URGENT FIELD SAFETY NOTICE

Manufacturer SRN:	DE-MF-000020091
FSCA Reference:	626803 CARDIOHELP - Replacement of slide rail holder
FSCA Type:	New
Affected Product:	CARDIOHELP-i (article number 701048012) CARDIOHELP-i (article number 701072780, US Variant)
Affected Serial No.:	Refer to Annex I
Unique Device Identifier:	04037691658384 04058863074863
For Attention of:	Users of the CARDIOHELP-i

Figure 1: CARDIOHELP slide rail- exploded view

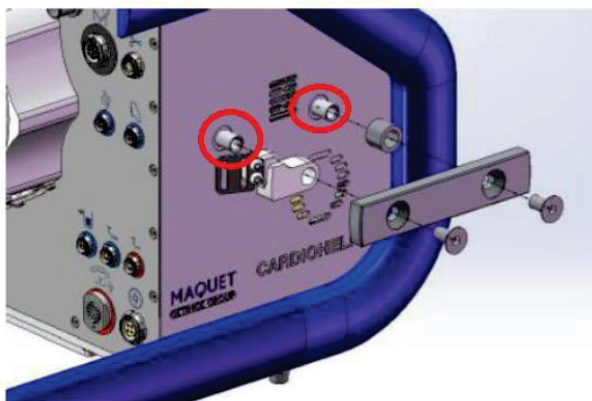
The slide rails are located on the lateral aspects of the CARDIOHELP system. They are attached to the housing of the CARDIOHELP system with the slide rail holder (see red marks in Figure 1). As shown in Figure 2, the slide rail holder consists of a nut bolt welded onto a plate.

It was found that the fixation (weld) employed by the supplier of the nut bolt to the slide rail plate was insufficient. The deficient weld allows the nut bolt to break off from the slide rail plate with slight manual force.

- Replacement of the slide rail holders.
